4.3 Bandwidth Consumption Forecast – Residential Access

4.3.1 FTTH

Figure 10: Forecasted Downstream Demand – Moderate Demand Scenario, FTTB

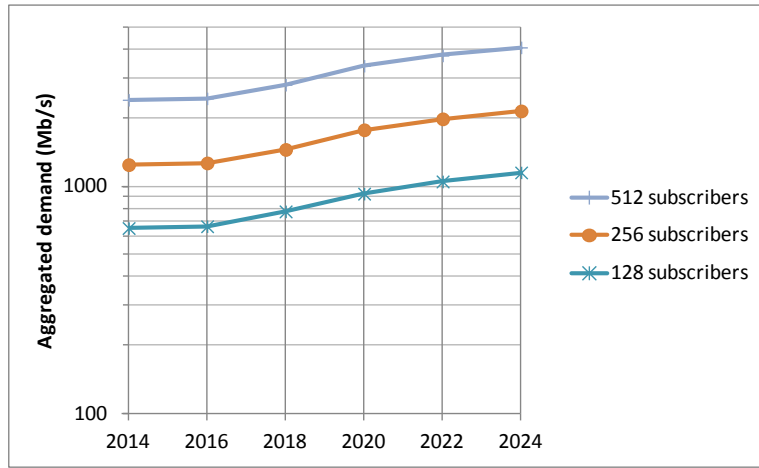
Comment [e2]: Leave original figure in.

Figure 11: Forecasted Downstream Demand – Heavy Demand Scenario, FTTB

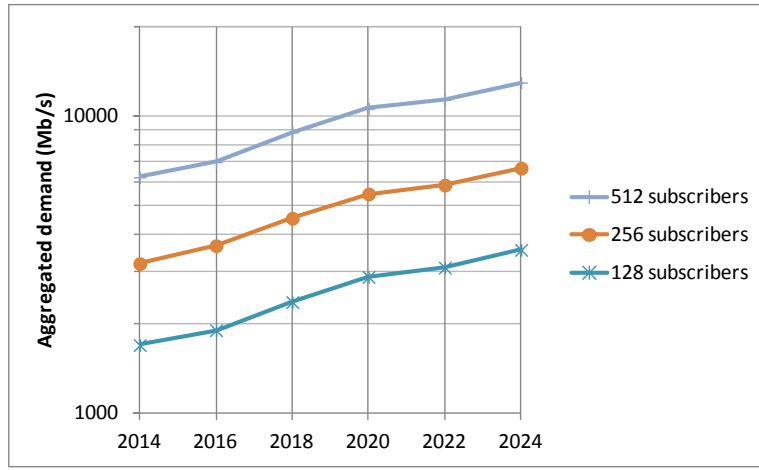
Comment [e3]: Leave original figure in.
